SUTHERLAND SHIRE COUNCIL ASSESSMENT REPORT

Panel Reference	PPSSSH-9
DA Number	DA19/0756
LGA	Sutherland Shire Council
Proposed Development	Demolition Of Existing Structures, Construction Of A Residential Flat Building With Basement Levels, Rooftop Communal Space, Forty-nine (49) Units With An Affordable Housing Component And Strata Subdivision
Street Address	310, 312 and 314 Taren Point Road Caringbah
Applicant/Owner	MBD Developments
Date of DA lodgement	27 September 2019
Total number of Submissions Number of Unique Objections	<ul style="list-style-type: none"> Two (2) submissions in support None (0)
Recommendation	Approval
Regional Development Criteria (Schedule 7 of the SEPP (State and Regional Development) 2011	Private infrastructure and community facilities over \$5 million
List of all relevant s4.15(1)(a) matters	<ul style="list-style-type: none"> Environmental Planning Instruments: <ul style="list-style-type: none"> State Environmental Planning Policy (Affordable Rental Housing) 2009 State Environmental Planning Policy No. 65 – Design Quality of Residential Apartment Development (SEPP 65) State Environmental Planning Policy No. 55 – Remediation of Land State Environmental Pla

Figure 8: Set in planter within atrium (red clouded area indicates the portion above the MRV loading area)

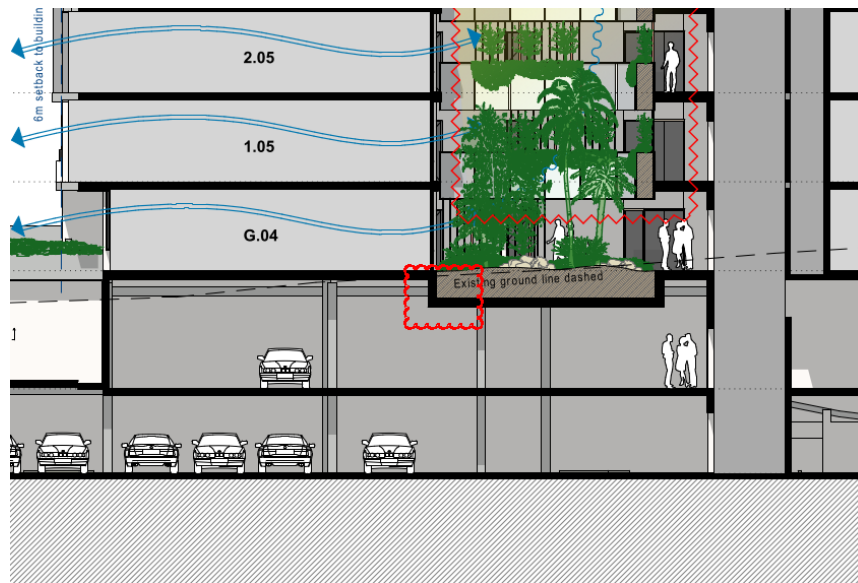
Swept path diagrams indicated that the proposed basement arrangements provide satisfactory circulation and aisle dimensions to facilitate a MRV waste collection vehicle, and to accommodate the B99 car size. It is noted that there is an error in the depiction of the set-in garden provided within the atrium in section, as is partly situated above the area specified for the MRV and if constructed in this manner will likely reduce the clearance such that it will not function as intended or at all. See **Figure 8** below.

The area is correctly depicted in plan, and can be easily rectified with a condition to ensure that the set in to the slab does not occur above this space, and instead the garden is to be built up over in this area with sufficient depth to sustain ground cover vegetation. Subject to a condition in this respect the proposal is assessed as satisfactory with regard for parking and basement design considerations.

Figure 9: north-south section through the G.06 terrace and depicts the pathway and floor levels of the adjoining approved development at 306-308 Taren Point Road.

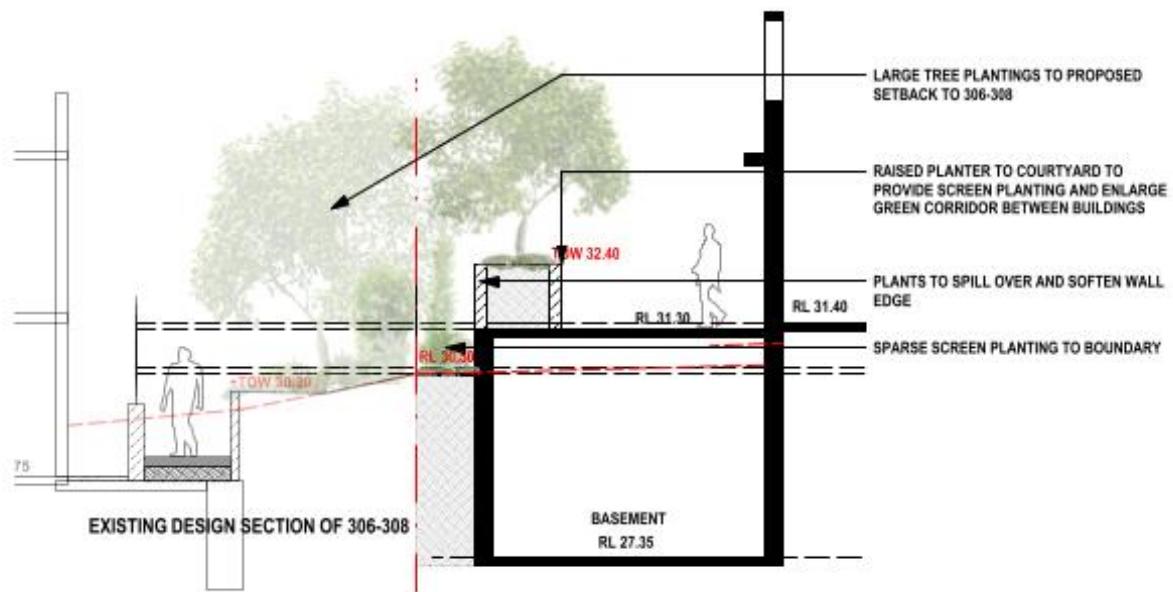
The basement entry produces an unavoidable elevated area above that will have a finished floor level approximately 600mm to 1m above existing ground level. This level cannot be reduced further as it is a by-product of the necessary 3.5m clearance for an MRV service vehicle. It is proposed to utilise the area above for private terraces, similar to the outcome achieved on the neighbouring site to the south, which is considered an efficient use of this space subject to appropriate controls to avoid overlooking and visual intrusion upon the lower property to the north. The applicant proposes the use of 1.1m high planter beds along the full length of the northern extent of the elevated terrace for this purpose. A section through this area is shown at **Figure 9** below.

Upon review of the section diagram, an occupant standing on that terrace will have a clear line of sight over a standard fence on the boundary, with vegetation solely relied upon to maintain visual amenity. This is not a reliable solution or an acceptable outcome for either party as there is no guarantee that the landscaping will be successful in this purpose and in any event will take time to establish. It is therefore recommended that in addition to the planting proposed, a 400mm high louvered privacy screen is erected above the northernmost wall of the planter box. Subject to such a condition, the use of the elevated structure is unlikely to generate any significant impacts for neighbours and will afford additional privacy to occupants.
